Advanced FEA Crack Growth Calculations for Evaluation of PWR Pressurizer Nozzle Dissimilar Metal Weld Circumferential PWSCC

Sponsored by: EPRI Materials Reliability Program

Meeting on Implications of Wolf Creek Dissimilar Metal Weld Inspections
DEI Offices, Reston, Virginia and via Webcast

NRC Questions and Comments on the Industry Advanced FEA Draft Report

Effect of Multiple Through-Wall Crack Segments (cont'd)

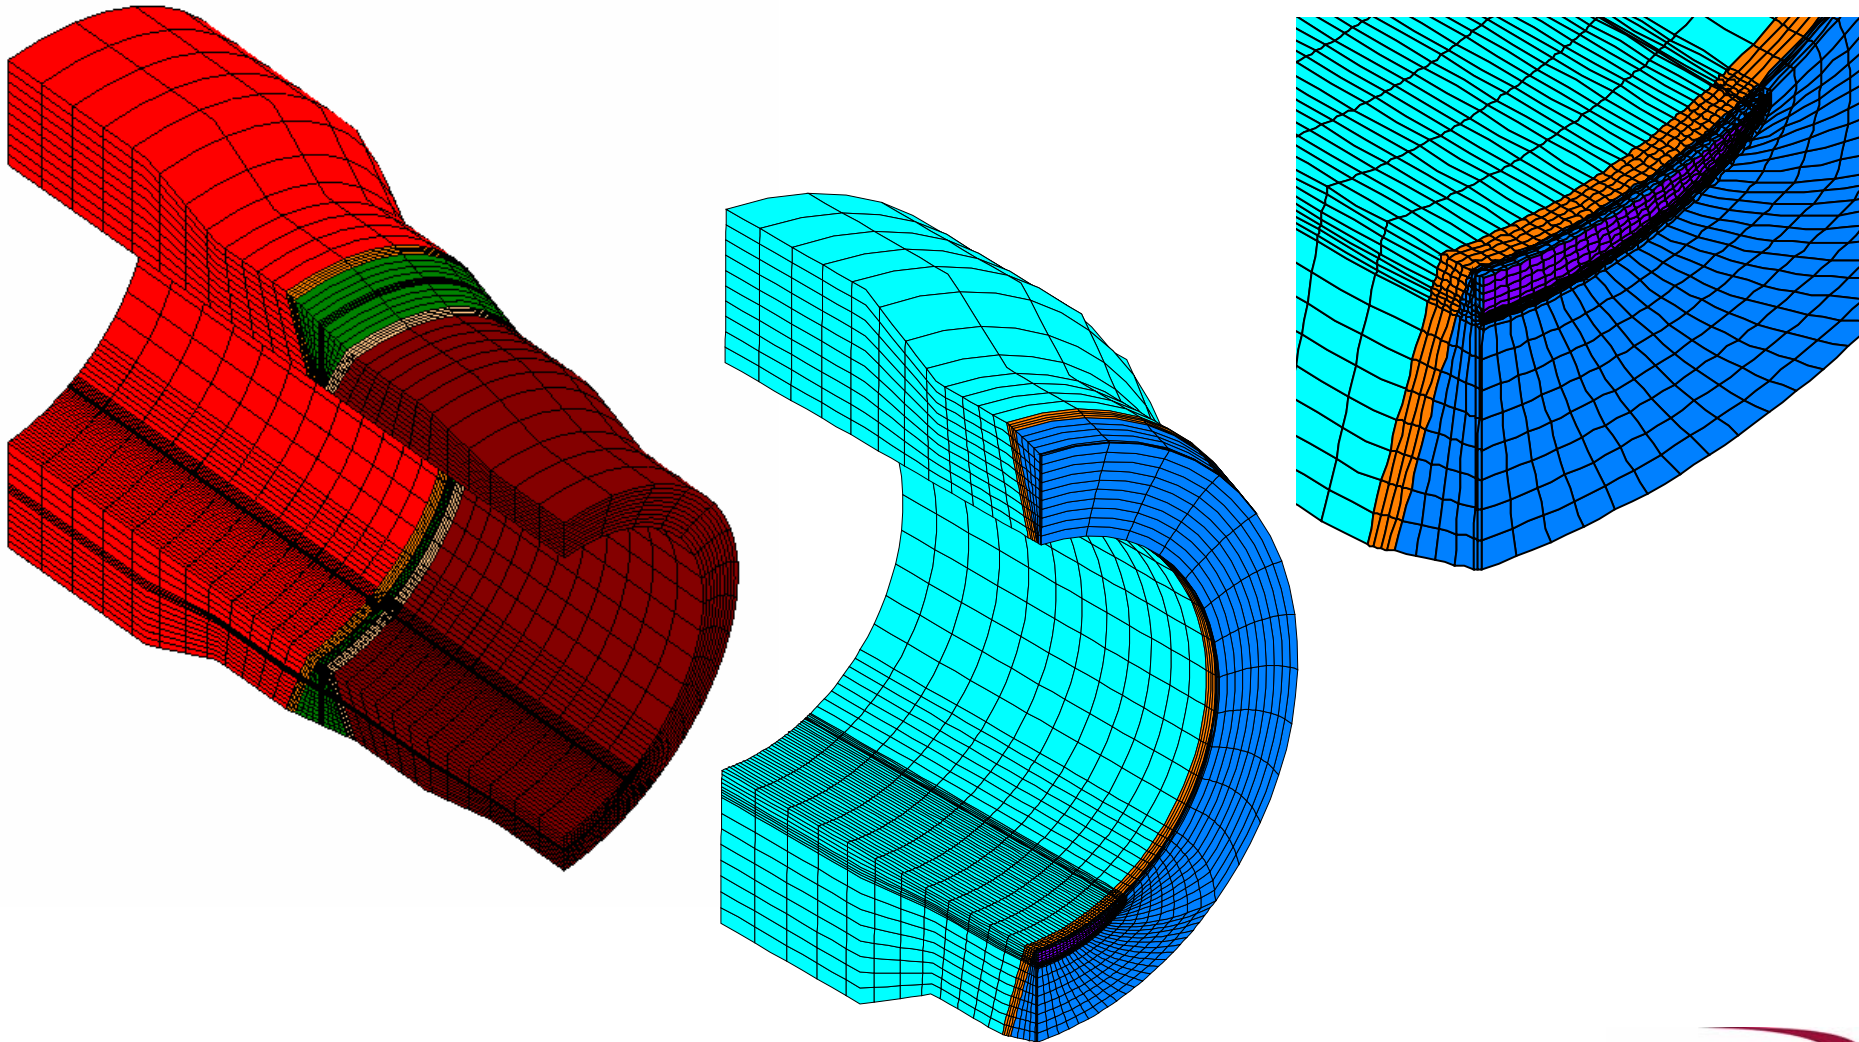
- Substantial margin beyond the evaluation criteria exists for nearly all cases in main matrix
 - Applying a leak rate margin factor of 10 rather than 4 on the 0.25 gpm detectability limit results in all 14 of the most limiting cases* in the main matrix satisfying the evaluation criteria with one exception (Case 44c)

- A leak rate margin factor of about 9 does satisfy the evaluation criteria for Case 44c
 - All other cases in the main matrix very likely satisfy the evaluation criteria with a leak rate margin factor of 10 based on the compiled leak rate and stability data

- A leak rate margin factor of 10 has historically been applied in long-term regulatory LBB assessments
 - The most limiting surge nozzle case (Case 17b) is predicted to have an initial through-wall leak rate of 2.6 gpm, with the leak rate increasing to 69 gpm when the load margin factor decreases to 1.2, indicating robustness with respect to the value of the leak rate margin factor

- Given the above points, the matrix results show sufficient margin to address modeling uncertainties such as those associated with the potential for multiple through-wall crack segments
- More detailed evaluation of the effect of multiple through-wall crack segments may be considered in the context of longer-term evaluations
 - More detailed evaluations will require significant additional developmental effort
 - Current study has had benefit of significantly refining crack growth evaluation tools, but explicit evaluation of multiple flaws is an emerging area
